MAVStepper™ VIG-520 Jumper 2 Reset

Change Jumper 2 to Full Duplex

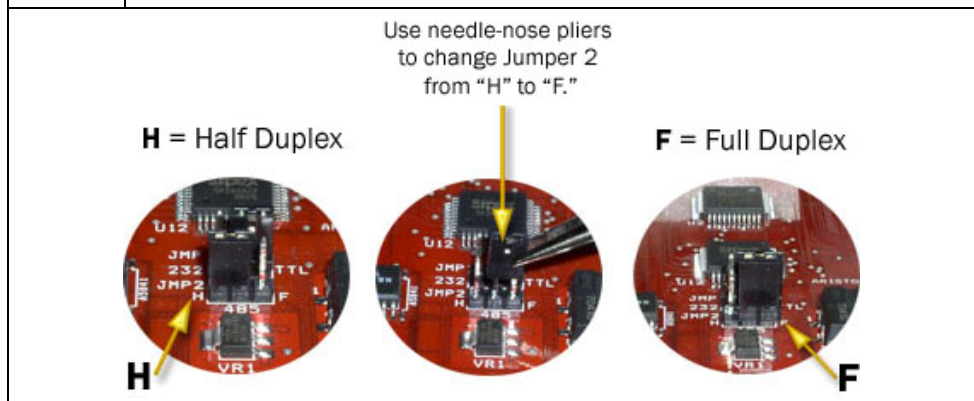
To support Aristocrat Mystery and Progressive game features, Jumper 2 on VIG-520 boards must be set to “F” (Full Duplex) in MAVStepper™ machines. Although this adjustment is currently a part of the manufacturing process, machines that were installed in the field prior to January 01, 2008 may require on-site adjustment.

If necessary, VIG-520 boards with Jumper 2 set at *Half Duplex* (H) must be changed to *Full Duplex* (F) in MAVStepper machines.

Step	Description
1.	Use needle-nose pliers to remove the shunt from the first and second pins of the Jumper 2 header.
2.	Slide the shunt onto the second and third pins of Jumper 2, nearest to “F.”
